Agenda

Council Meeting

7.00pm, Tuesday 16 February 2021

Figure 23 – Current western elevation of Buildings A and B (12 and 10 storey)

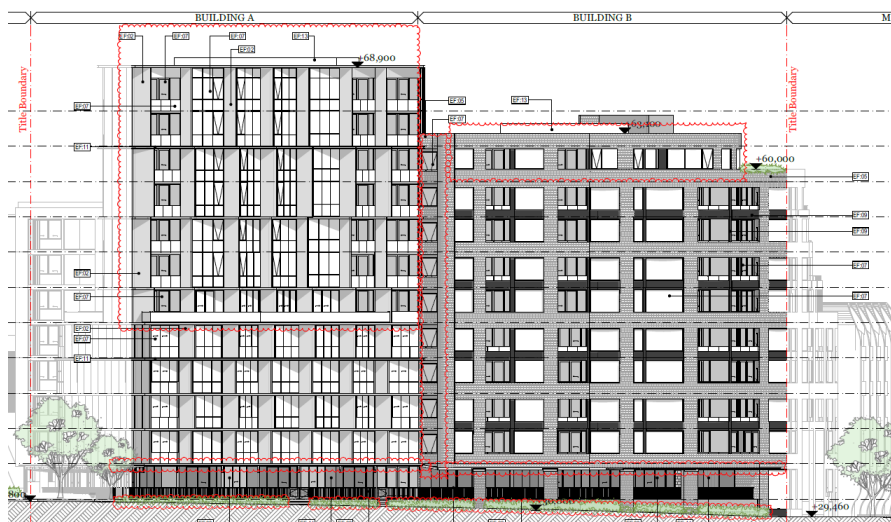
however, as will be discussed below, deletion of Levels 6 and 7 will provide for a better relationship to Building C and a more pronounced street wall to Main Street. This will be conditioned accordingly.

Figure 25 – current proposed northern elevation of Buildings A and D (12 and 9 storey)

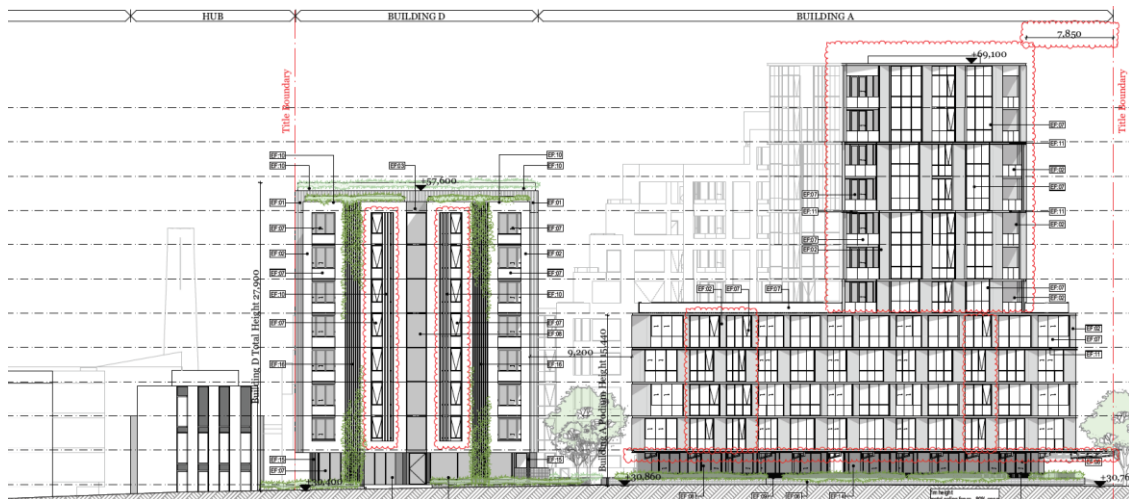
189. Mr Sheppard was also concerned with the height of Building D, recommending that this be reduced by one storey i.e. from 9 storeys to 8 storeys. Council officers, however, are not satisfied that a reduction of one storey is sufficient to achieve a graduated height to the Artisan East precinct. Based upon the visual analysis of Council Officers, it is suggested that three levels should be removed from Building D (i.e. 6 storey height), specifically mid-levels Levels 3, 4 and 5 in order to provide a more comfortable transition to the east as demonstrated in the images below. This will also result in a building comparable in scale to the podium height of Building A.

Figure 27 – Recommended Northern elevation of Buildings A and D reduced to 10 and 6 storeys

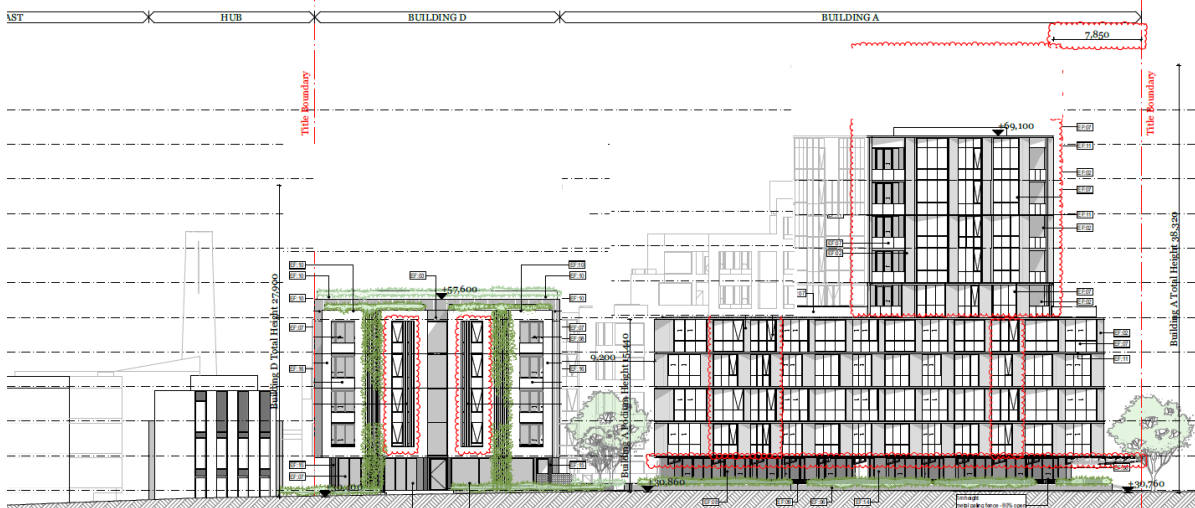
190. The removal of the mid-levels of Building D also ensures that the stepping down in building height proposed to the eastern side of this building is maintained. Additionally, the reduction in the building height to Building D is also expected to improve the level of sunlight within the central communal courtyard at Level 1 and the open space area between Artisan West and Artisan East. The deletion of Levels 3, 4 and 5 of Building D is subsequently recommended as a condition on any permit that issues.

Figure 31 – Current Southern elevation of Buildings B and C

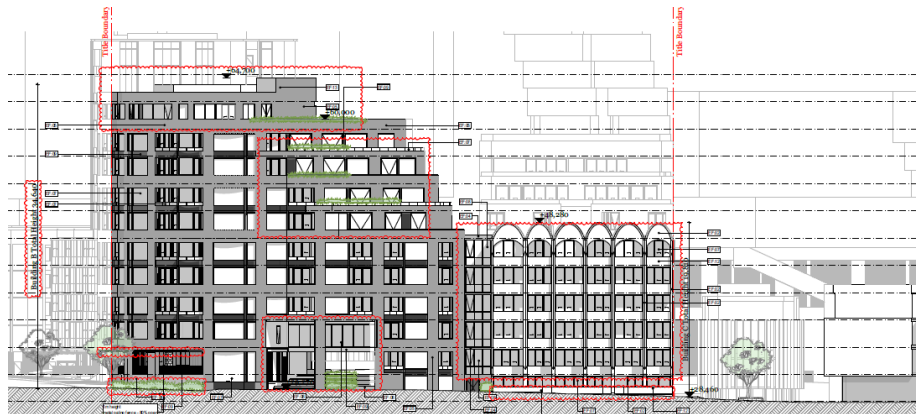
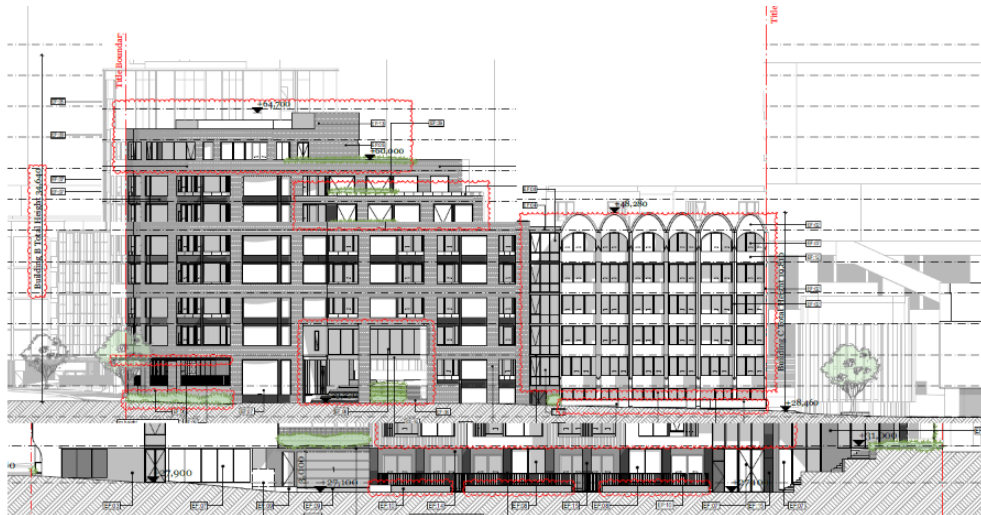
191. Reducing the height of Building B as previously discussed will also provide a more comfortable height transition between Building B and Building C in addition to reducing the stepping to the eastern side of the building as illustrated in Figure 30 below. While Mr Sheppard had recommended removing Levels 8 and 9, it is suggested that the deletion of Levels 6 and 7 would have the added benefit of increasing the setbacks from the podium, thereby reducing the visual bulk of the upper levels and created a more pronounced street wall. The deletion of Levels 6 and 7 will be conditioned accordingly.

Figure 44 - Apartment B02.04 with window to the void

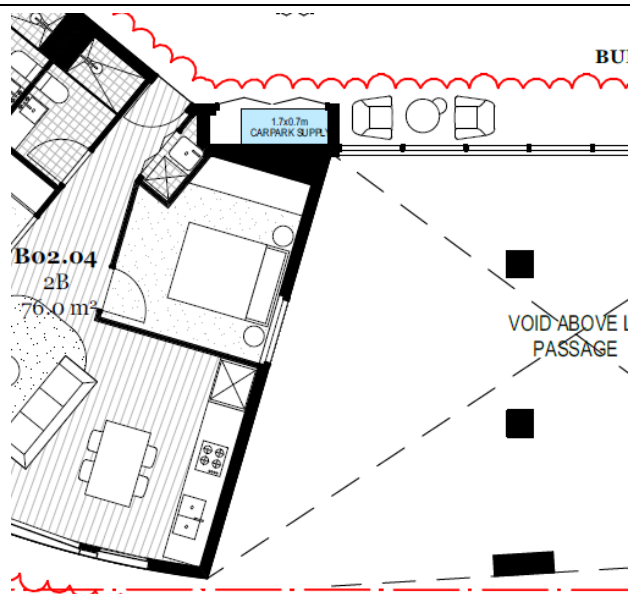
246. All habitable room windows have direct access to natural light, with none relying on borrowed light.
247. Concern is raised with the level of daylight and amenity afforded to the bedroom window of Apartment B2.04, which faces onto the entrance void. In addition to poor daylight, the amenity of this room is also likely to be adversely affected by noise and lightspill (from illumination of at night) from within the entrance void. As such it is recommended that this apartment be reconfigured to relocate the bedroom area away from the void area. This is recommended as a condition of any permit that issues.

- (o) Redesign of Apartment B2.04 to re-orientate the bedroom from facing into the void area to the pedestrian entry/lobby;
- (p) Location of awning windows to be clearly depicted on floor plans (consistent with elevations);

Figure 29 – Stair from the Paper Trail to Warson Crescent (current proposal)

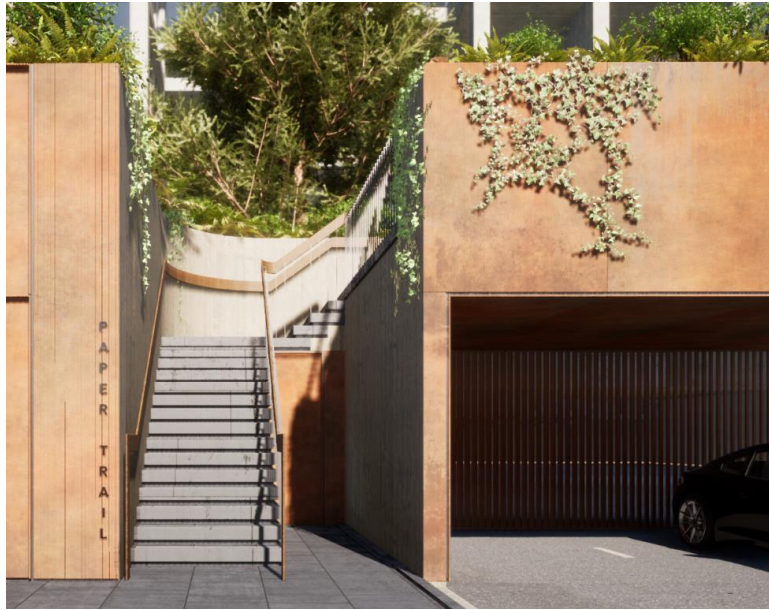
199. A stair connection is also provided mid-way along the Paper Trail to the street to the east (northern extension of Warson Crescent) between Workshop North and Wetlap Precincts. However, concern is raised in relation to the legibility and visual connection between the street and the Paper Trail. The applicant has responded providing greater openings to the balustrade and landing and illustrated in the images below (provided 18 October 2020). This is supported and should be incorporated by way of condition on any permit that issues.

Figure 52 – September Equinox Shadow diagrams

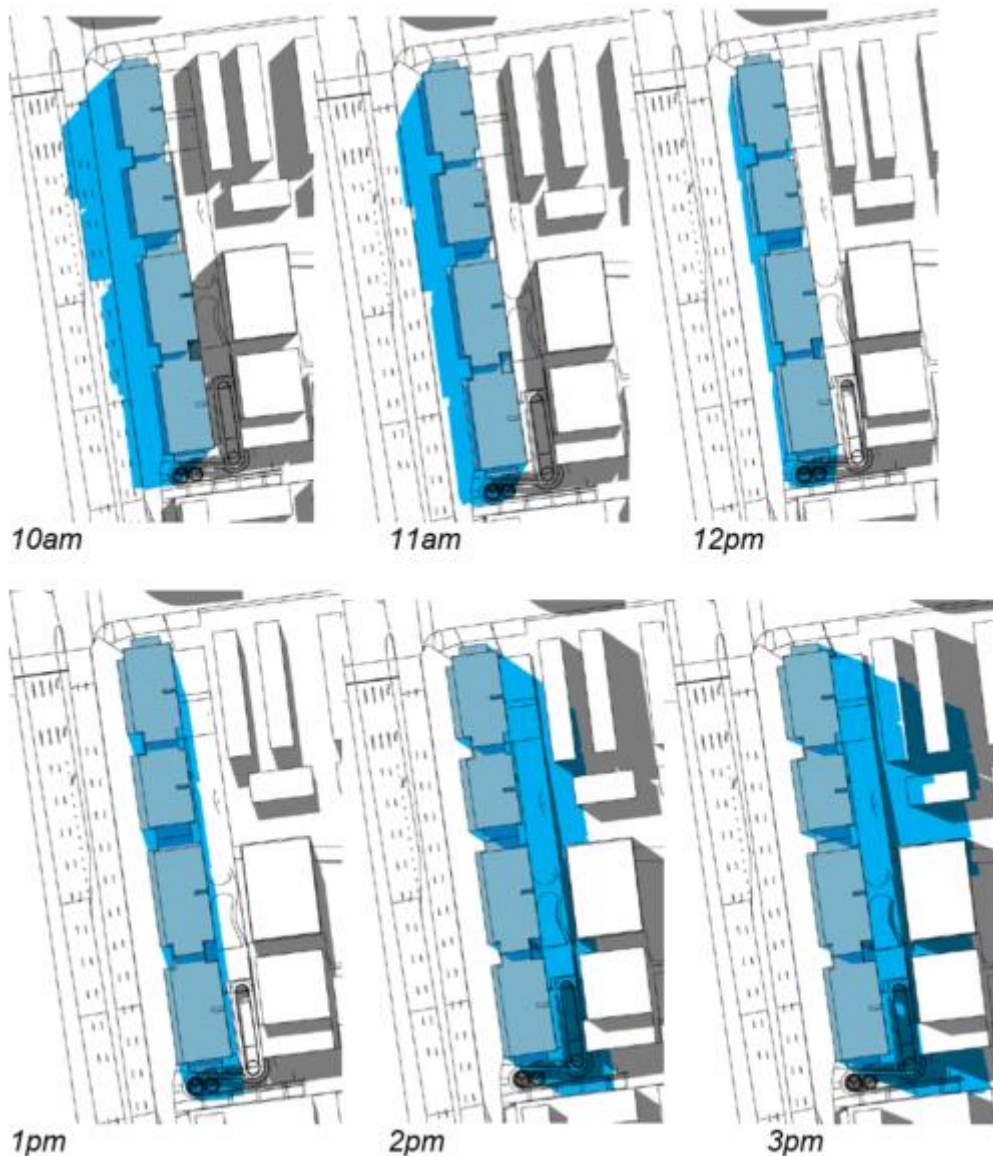
313. The outdoor pool, being sub terrain, would receive little direct sunlight. While shadow diagrams for 21 June have not been provided, based upon the extent of shadow at the September Equinox (see below), it would not be expected that the lawn area would meet this requirement, being overshadowed in by Precinct 5 to the east in the morning and the proposed development in the afternoon. Given the scale of the proposal, accommodating 206 apartments, the poor response to Standard D8 is considered unacceptable.

Figure 39: Sketch plans – southern wall of Loft apartment

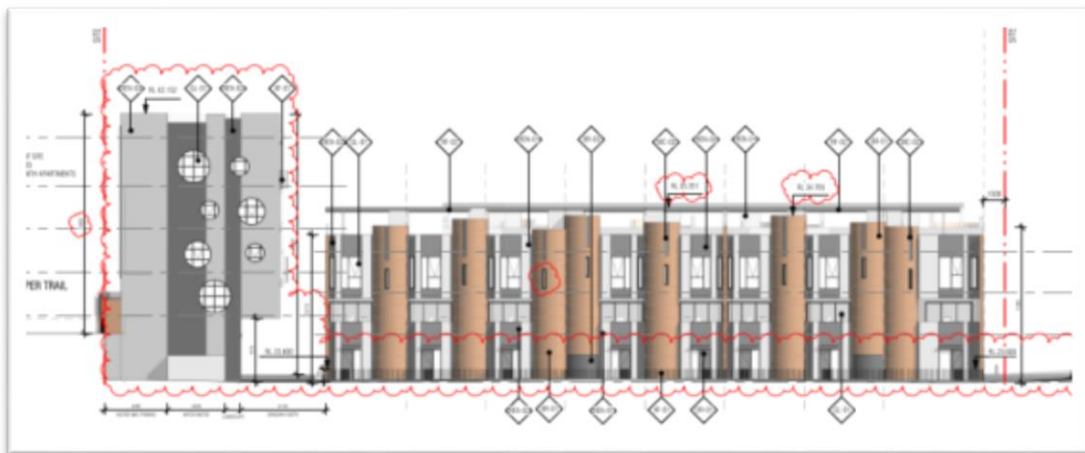
188. A similar concern was raised by Council’s Urban Designer with the presentation of the eastern walls of Townhouses 7 and 15, with these dwellings also on a corner. It was recommended that further articulation be explored to minimise the large portion of blank side interfaces. These frontages are demonstrated in Figure 40.

Figure 48: Decision Plans and Sketch Plans: differences to residential entrance

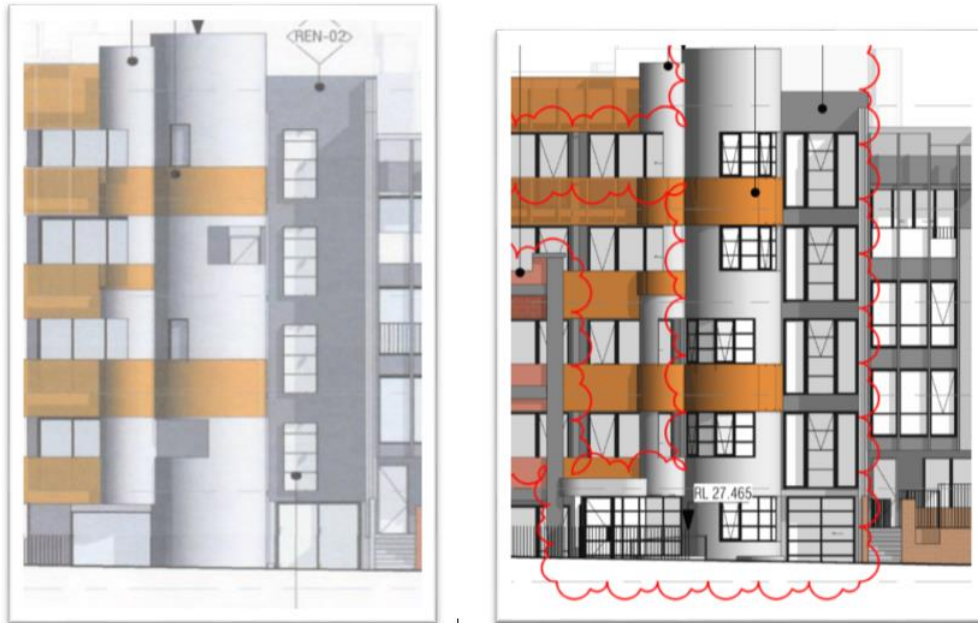
Plans, as demonstrated in Figure 48. This change, along with the increased size/number of windows within the levels above, improves the integration of the façade with the Paper Trail and increases the passive surveillance opportunities between these spaces. A condition facilitating this change should be included in any permit issued.
